ADDENDUM NO. 2

TO THE BID DOCUMENTS FOR THE
800MHz GENERATOR PROJECTS – SITES LEASED THROUGH AMERICAN
TOWER – SANDY, PADUA, MOUNTAIN PASS

DATE: July 6, 2022

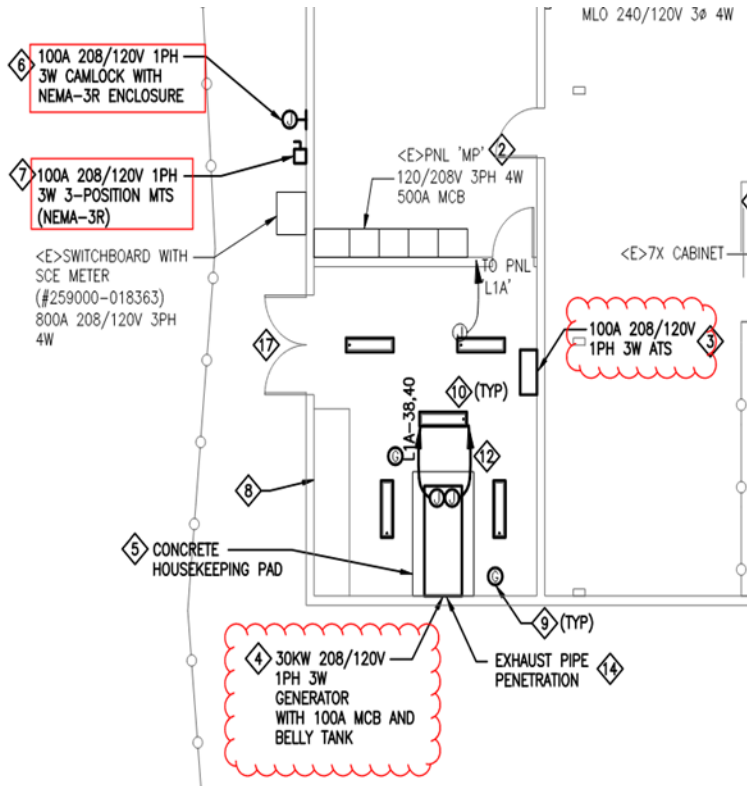
Q16: Confirm if generator at Mtn Pass is single phase or three phase. All others are coordinated three phases.

Q17: Single Line Diagram (SLD) shows three phase feeder (conduit & wires) and feeder breaker 3-pole. However, description on SLD is single phase. Specification 1.1.1 specifies single phase.

A16: Per E-1.1, generator shall be 1Ph feeding existing Panel 'A', which is 1ph.

A17: Contractor shall provide 1ph circuit breaker and feeder accordingly. It shall be single phase.
